Expert Agency Critique of the Preliminary Final EIS and the Federal Action Necessary on the Proposed Pebble Mine Permit Application

Expert Comments on Preliminary Final EIS and 404 Permit Application

- Alaska Department of Fish and Game, March 23, 2020 >
- Alaska Department of Natural Resources, March 23, 2020 >
- Alaska Department of Environmental Conservation, March 23, 2020 >
- U.S. Environmental Protection Agency, March 26, 2020 >
- U.S. Fish and Wildlife Service, April 2, 2020 >
- U.S. National Park Service, April 2, 2020 >
- Bureau of Safety and Environmental Enforcement, March 23, 2020 >
- U.S. Coast Guard, March 23, 2020 >
- Lake and Peninsula Borough, March 23, 2020 >
- Curyung Tribal Council, March 23, 2020 >
- Curyung Tribal Council, March 30, 2020 >
- Nondalton Tribal Council, March 23, 2020 >
- Nondalton Tribal Council, April 3, 2020 >

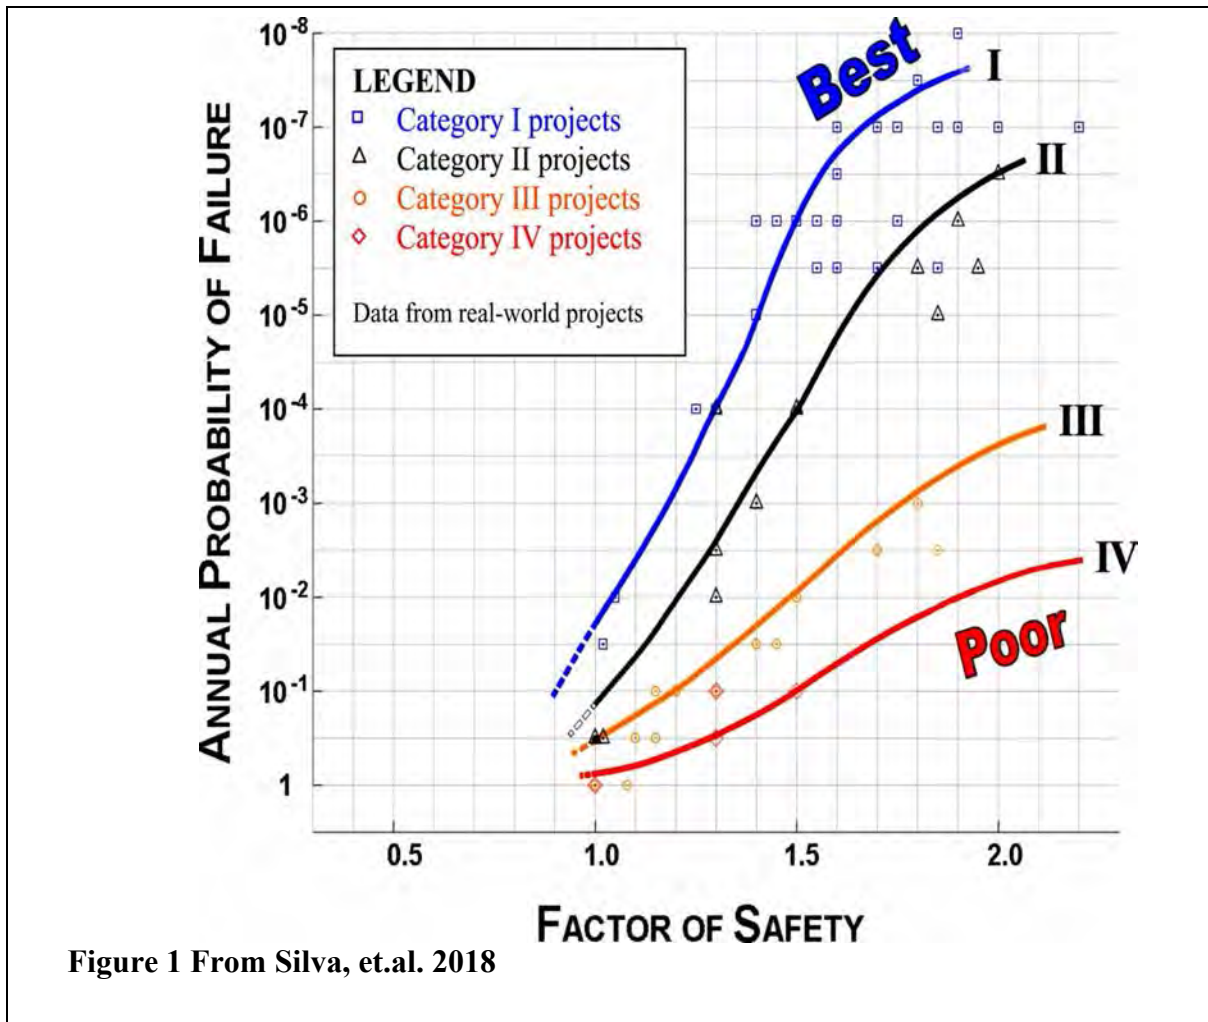
- Both Section 4.27.8.8 and Section 4.27.9.7 include a bullet implying that dam embankments would be designed and constructed with a factor of safety value of “1.9 to 2.0.” As seen in Figure 1 to this memorandum, increasing the factor of safety is not as effective in reducing probability of failure as raising the standard of care for the design, construction, and operation of a dam (Silva, et.al., 2008). Increasing the factor of safety for embankments may not be an effective mitigation for risk.

Risk comparative chart for relative assessments

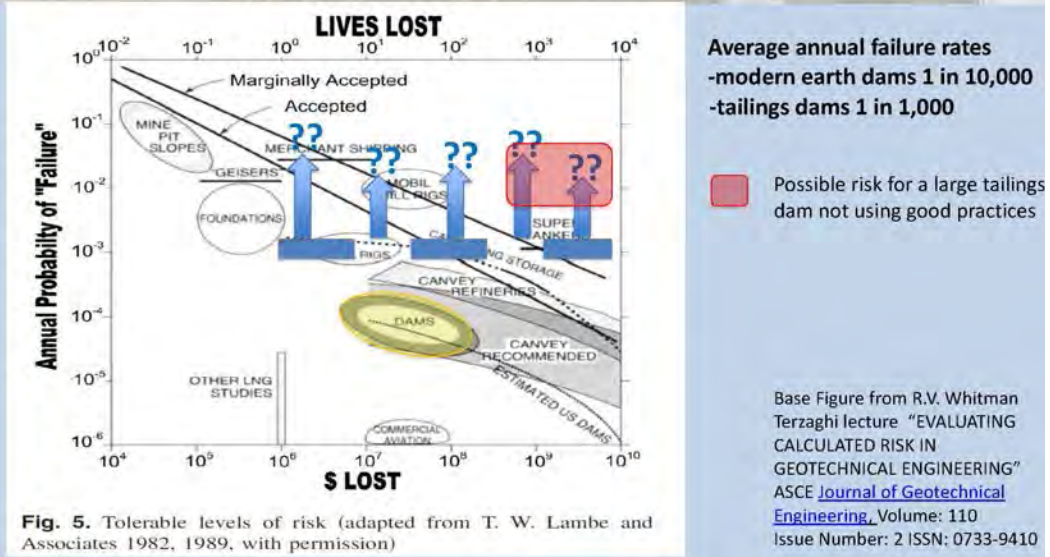
Figure 2 in this memorandum from Dr. Morgenstern’s paper shows the significance of regulatory compliance, referred to there as “codes and standards”, “engineering judgment” and “risk-based analysis” in a decision-making process.
